DOCKETED	
Docket Number:	20-MISC-01
Project Title:	2020 Miscellaneous Proceedings.
TN #:	240869
Document Title:	Green Hydrogen Coalition Comments - CEC Staff Workshop on Strategies to Model LDS
Description:	N/A
Filer:	System
Organization:	Green Hydrogen Coalition
Submitter Role:	Public
Submission Date:	12/7/2021 2:20:21 PM
Docketed Date:	12/7/2021

Subject: Staff Workshop on Strategies to Model Long Duration Storage

Re: Comments of the Green Hydrogen Coalition (GHC) following the November 17, 2021, CEC Staff Workshop on Strategies to Model Long Duration Storage

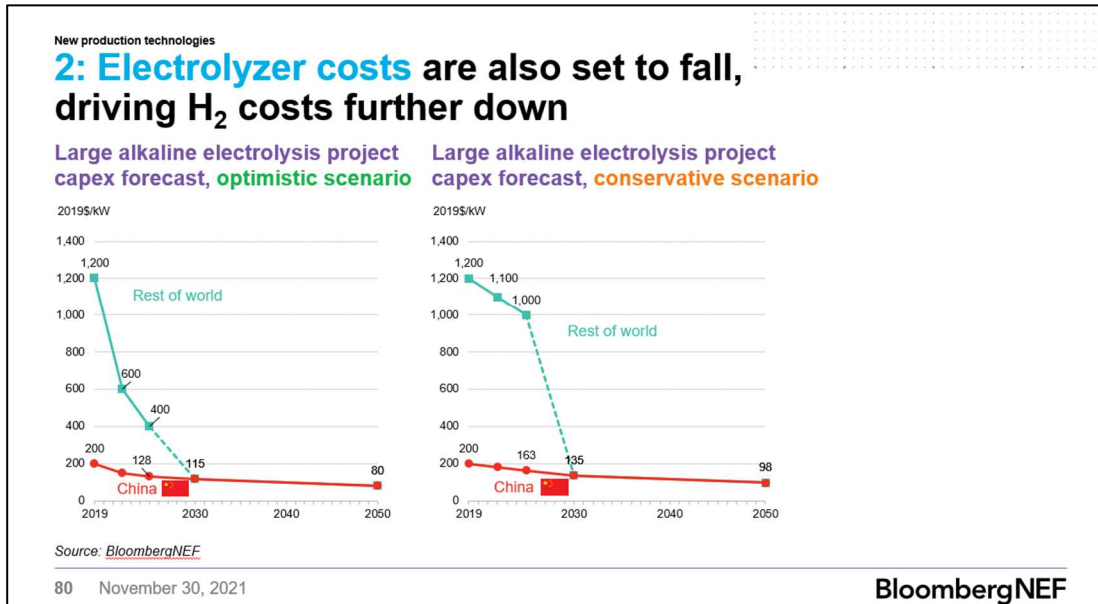
RESOLVE electrolyzer CapEx costs are too high and should be revised.

GHC submits that RESOLVE electrolyzer CapEx costs of 900 Euro/kW by 2025 to 430 Euros/kW by 2045 are too high and should be revised. GHC recently analyzed electrolyzer CapEx costs through its HyDeal Los Angeles (HyDeal LA) Phase 1 Initiative.³ Findings from this analysis showed that electrolyzer CapEx costs are forecasted to be \$500/kW by 2025 and \$400/kW by 2030. These CapEx cost forecasts were derived from findings from HyDeal Ambition⁴ and interviews with HyDeal LA participants who are currently developing electrolyzer projects. Further, these CapEx cost estimates align with recent research from BloombergNEF and the US Department of Energy's (DOE) Hydrogen & Fuel Cell Technologies Office.

Overall, GHC contends that aligning electrolyzer CapEx costs with recent forecasts will improve the cost-competitiveness of green hydrogen and increase its attractiveness when compared to other storage technologies. For this reason, GHC asks that this study revise its CapEx cost forecasts and consider the most recent forecasts from HyDeal LA, BloombergNEF, and DOE's Hydrogen & Fuel Cell Technologies Office.

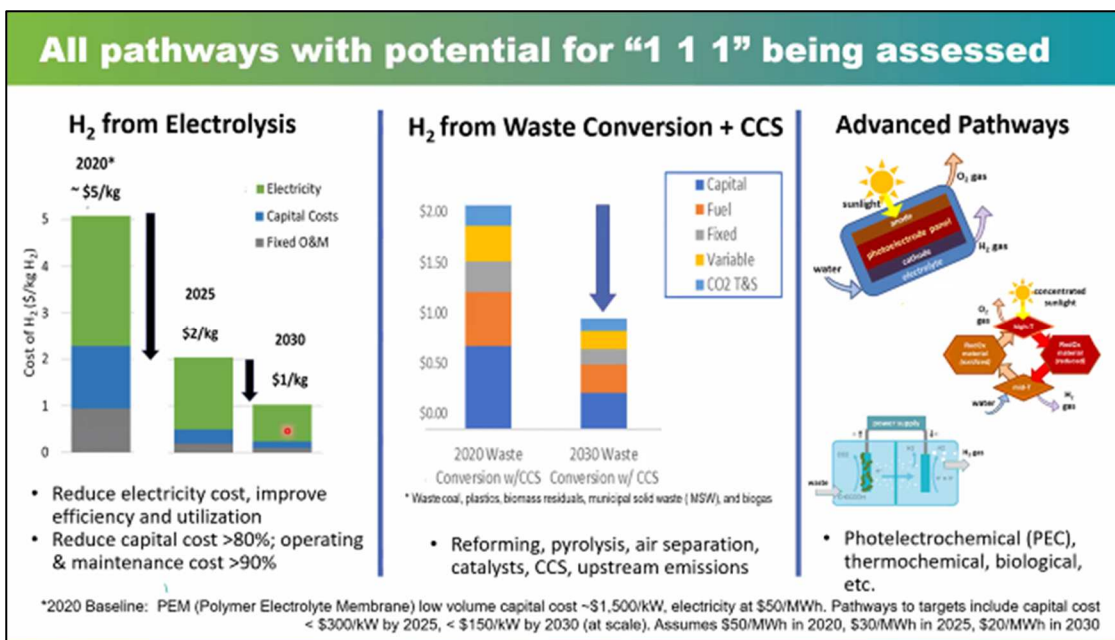
During our GHC Fall Event, on November 30, 2021, BloombergNEF presented electrolyzer CapEx forecasts from their recent report titled, *New Energy Outlook 2021*.⁵ Their research found that Alkaline electrolyzers are following a similar trajectory to solar and wind power - for every doubling in their cumulative installed capacity, costs have fallen by $18 \pm 6\%$. Further (see below), BloombergNEF presented two scenarios for electrolyzer CapEx forecasts – optimistic and conservative. Under an optimistic scenario, they found that CapEx costs are forecasted to be \$400/kW by 2025 and \$115/kW by 2030, and under a conservative scenario, they found CapEx costs are forecasted to be \$1000/kW by 2025 and \$135/kW by 2030.⁶

Additionally, during the GHC Fall event, Sunita Satyapal, Director of the Hydrogen & Fuel Cell Technologies Office at the DOE, presented a slide (see below) that showed that the DOE is targeting to get PEM electrolyzer CapEx costs to <\$300/kW by 2025 and <\$150/kW by 2030.⁷
